Product Change Notification

PCN-PCC-8469-2023

| Business Unit | Product Line Code | Type of Change | Action | Date of Issue |
|----------------------|-------------------|-----------------------------|-------------------------------|---------------|
| PCC - PCB Connectors | AAE | Product Change Notification | Notify Distributors and Field | 1/17/2023 |

Description for Product Change Notification

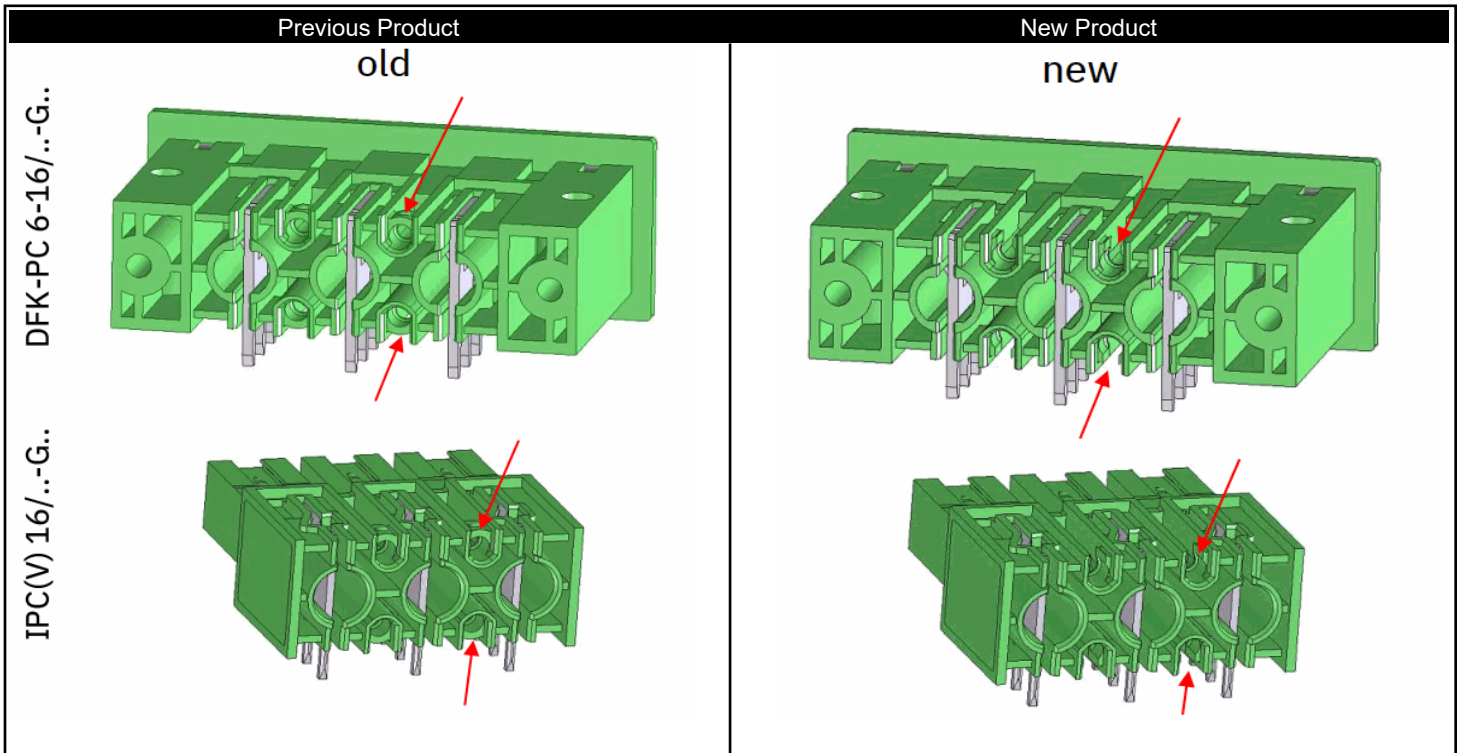
As part of the continuous improvement processes, the connecting ribs will be removed from the housings of IPC(V) 16/..-G.. and DFK-PC 6-16/..-G... This means that these items will have the same contour as the PC(V) 6-16/..-G headers. The external dimensions, pin layout, and technical data will not change. An old vs. new comparison drawing and an item are included within this notice.
